**PRE-APPLICATION CONFERENCE**  
**HILLSIDE FARM SUBDIVISION** (2017-014-PAC)  
Meeting conducted on Thursday, November 2, 2017 – 9:30 AM

Site Address	37400 NE North Fork Road, La Center, WA 98629
Legal Description	La Center, WA on tax parcel numbers 258901-000, 258919-000, 258922-000, 258971-000, 258972-0000
Applicant	Carleen Stephens, 24600 NE 98 <sup>th</sup> Court, Battle Ground, WA 98604 360-606-2408 <a href="mailto:StephensHillsideFarm@gmail.com">StephensHillsideFarm@gmail.com</a>
Applicant's Representative	Ed Greer, Greer & Greer, Inc. 13023 NE Hwy 99, Suite 7-126, Vancouver, WA 98686 Contact: 360.904.4964; <a href="mailto:ed@edgreer.net">ed@edgreer.net</a>
Property Owner	Carleen Stephens, 24600 NE 98 <sup>th</sup> Court, Battle Ground, WA 98604 Contact: 360.606.2408; <a href="mailto:carleenstephens@gmail.com">carleenstephens@gmail.com</a>
Proposal	<p>The applicant proposes to subdivide 43 acres into 86 residential lots that, upon annexation, will be zoned LDR-7.5 with an Urban Holding Overlay, and construct the associated infrastructure to support the proposed development.</p> <p>All existing structures will be removed except the residence in 208 N 348 ST will be retained

POTENTIAL WETLANDS PER COMMUNICATION FROM U.S. ARMY CORPS OF ENGINEERS (OCTOBER 2017)

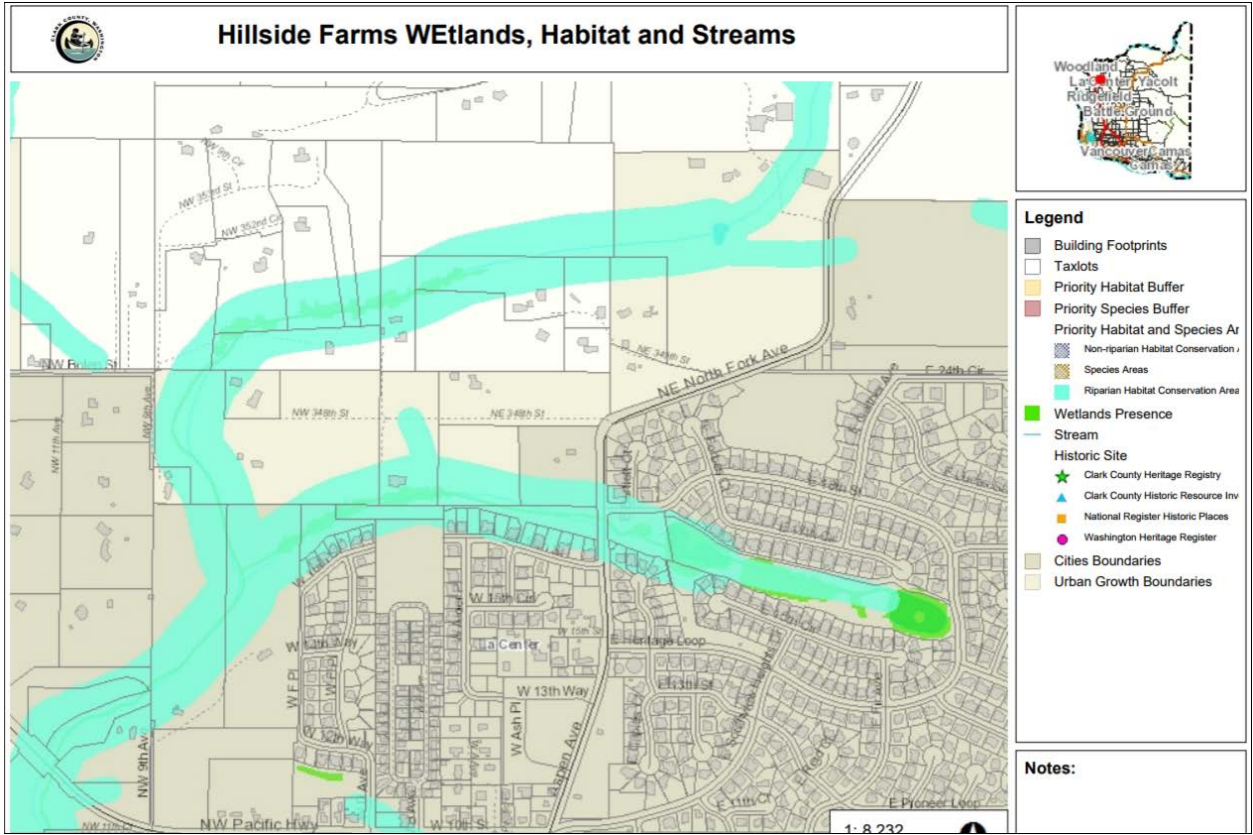
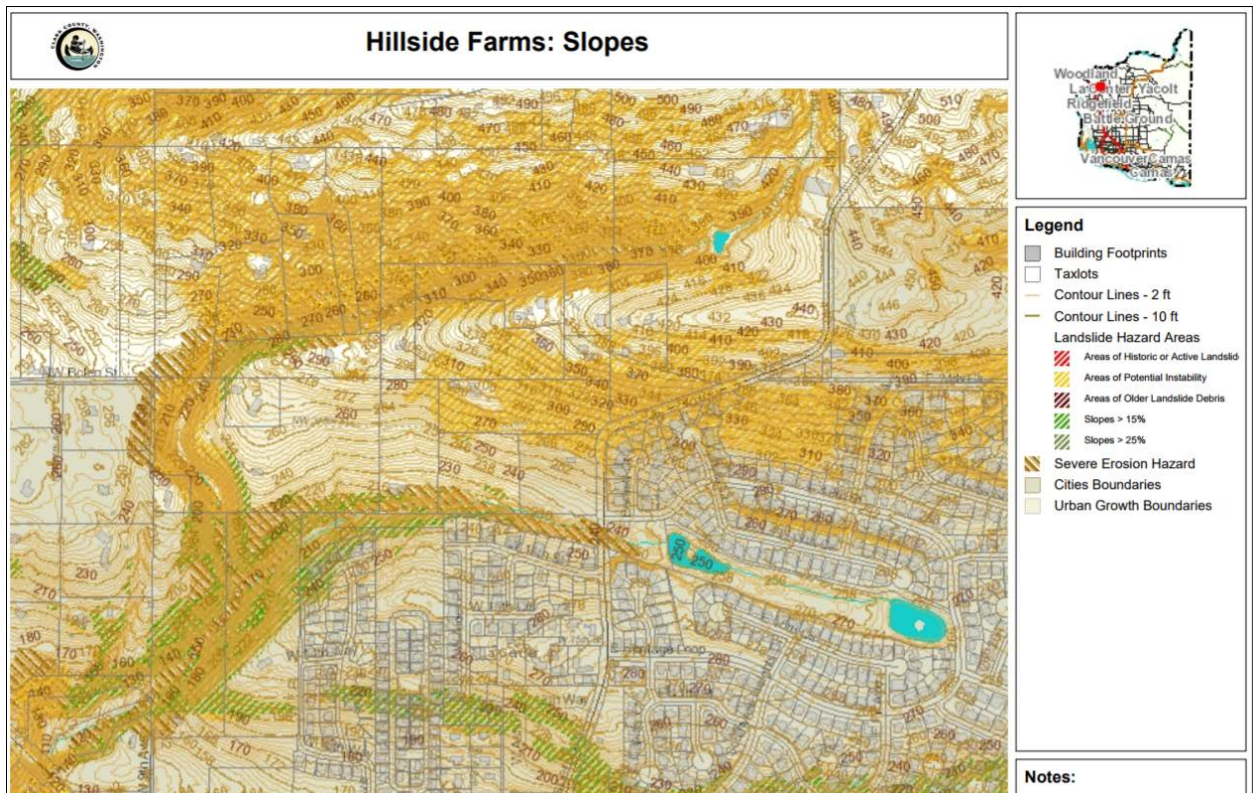
- Wetlands on the site must be reclassified using the 2015 Ecology Rating System (Hruby).
- Pervious trails and public facilities and utilities are allowed in wetland buffers, where there is no other reasonable alternative, based on topographic and environmental conditions.

- New lots shall not be platted in critical areas or critical area buffers (e.g., Lots 21, 22, and 23). (LCMC 18.300.050(4)(f) and 18.300.090(6)(e).
- Applications for development within critical areas or buffers shall demonstrate that all reasonable efforts have been examined with the intent to avoid and minimize impacts to critical areas and buffers. LCMC 18.300.050(5).
